ADDENDUM NO. 4

PROJECT NAME: UNL Devaney Sports Center Improvements
UNL PROJECT NUMBER: C100P098

DATE OF ISSUANCE: Wednesday, April 11, 2012

SHEET
M303
 ATTACHMENT NO.

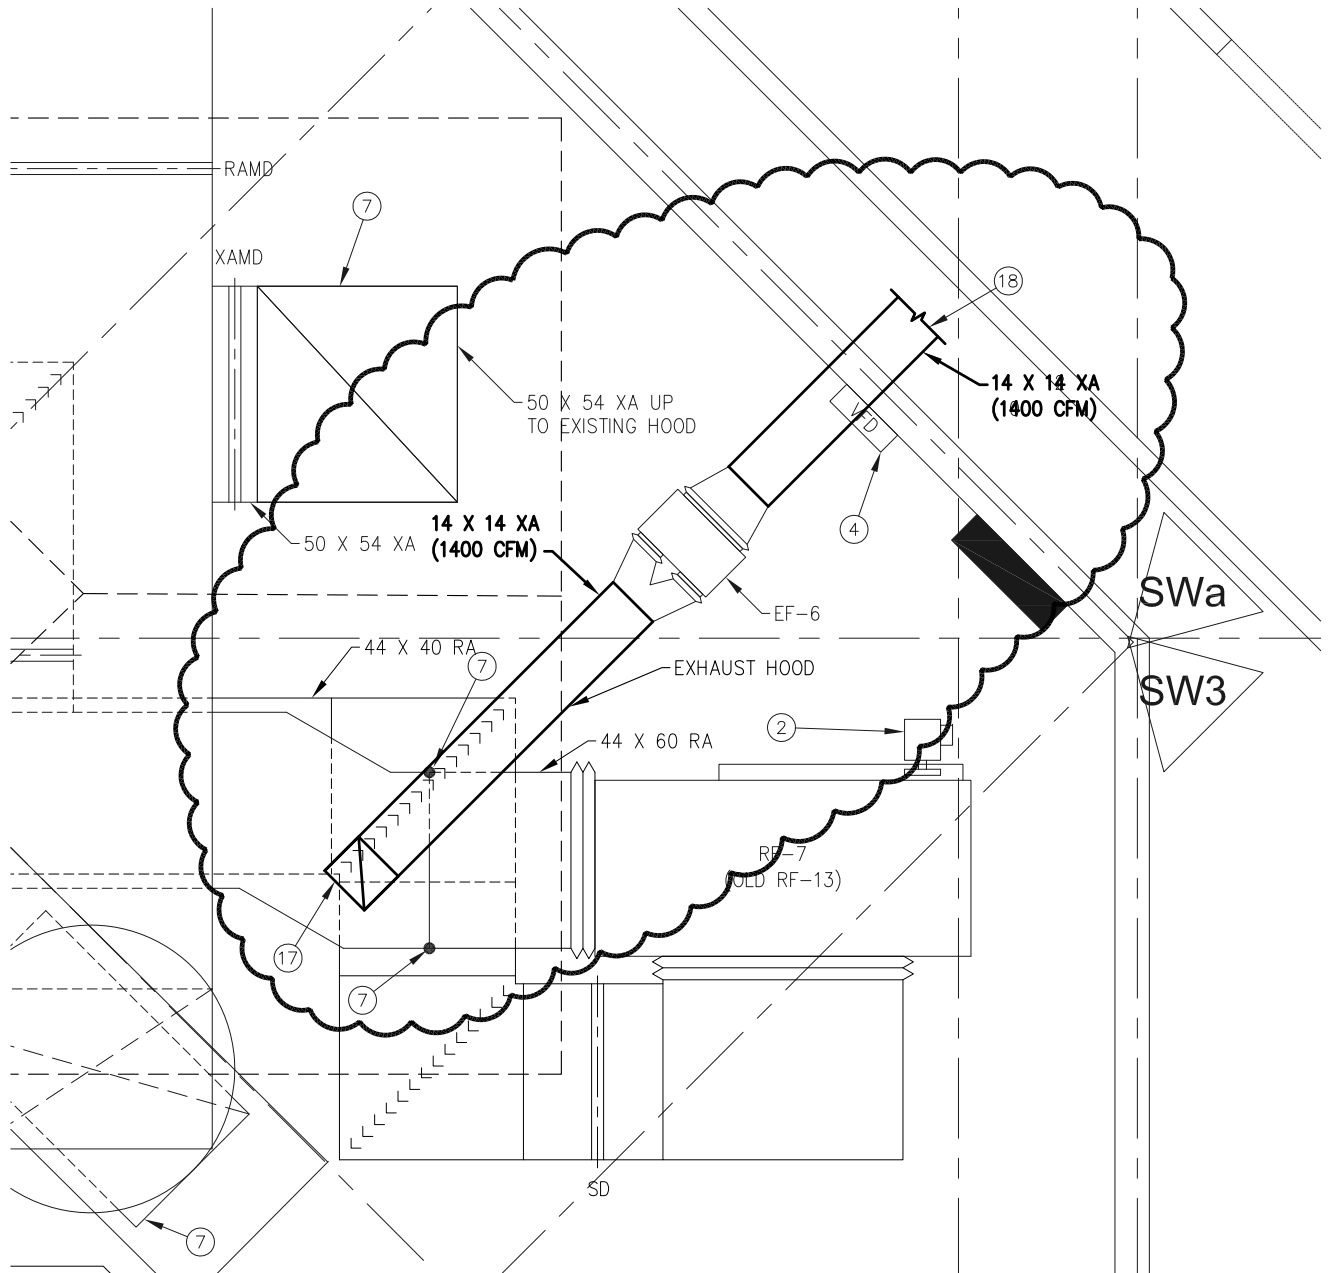
- 1. Sheet M303 – Catwalk Level Plan - HVAC
A. Added exhaust grilles and ductwork to serve the new Storage Rooms west of the Club Level.
B. See attachment 1M.
2. Sheet M401 – Enlarged Mechanical Room 138 – Mechanical & HVAC
A. Note 25 references sheet M204. See addendum #3 for sheet M204.
3. Sheet M408 – Enlarged SW Mechanical Room 540 – Mechanical & HVAC
A. Revised exhaust duct size from 14 x 12 to 14 x 14. See attachment 2M.
4. Sheet M600 – Mechanical Schedules
A. EF-6 has changed from a Z102HTDA to a ZC10. See attachment 3M.
5. Sheet M601 – Mechanical Details
A. The duct liner shall be removed from the Regain Box Detail. The Regain box shall be insulated with 1-1/2” duct wrap insulation to match the supply ductwork.

04/12/12
 SHEET
E202.B
 ATTACHMENT NO.
E1
 CDE

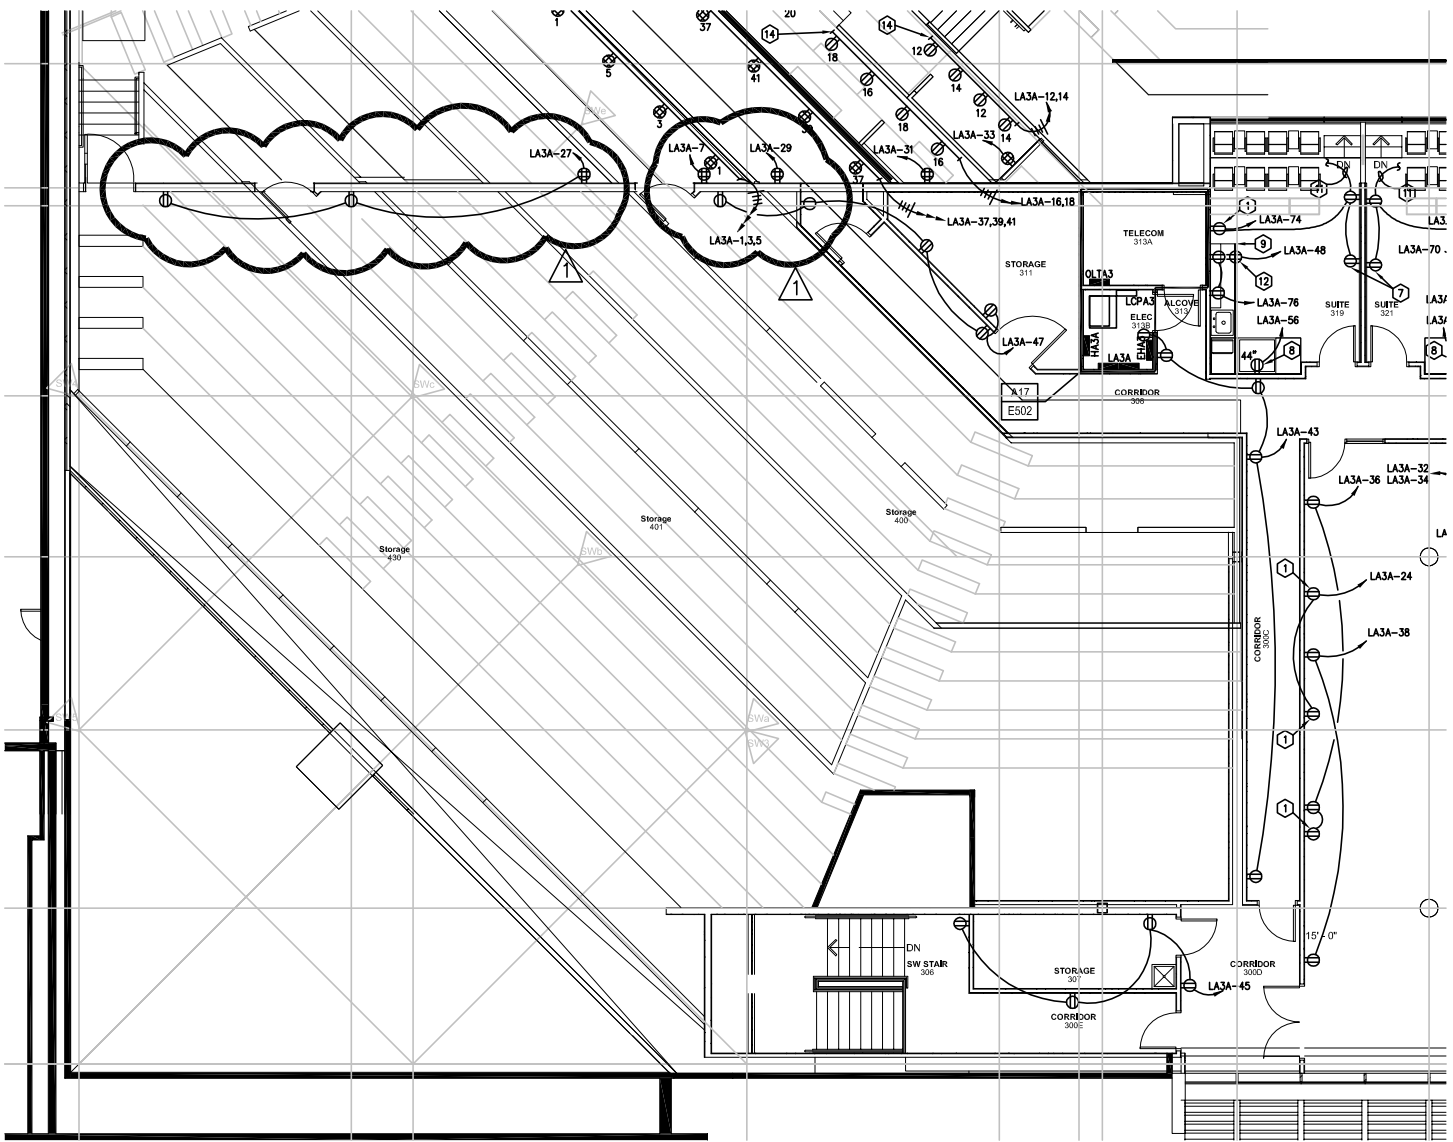
- B. Corridor 300D: Change Type 4S fixture to Type 4.
 - C. Add lighting in Storage 400, 401, 430 as shown on Attachment E1.
 7. Sheet E300.A – Arena Level Power Plan – Area A
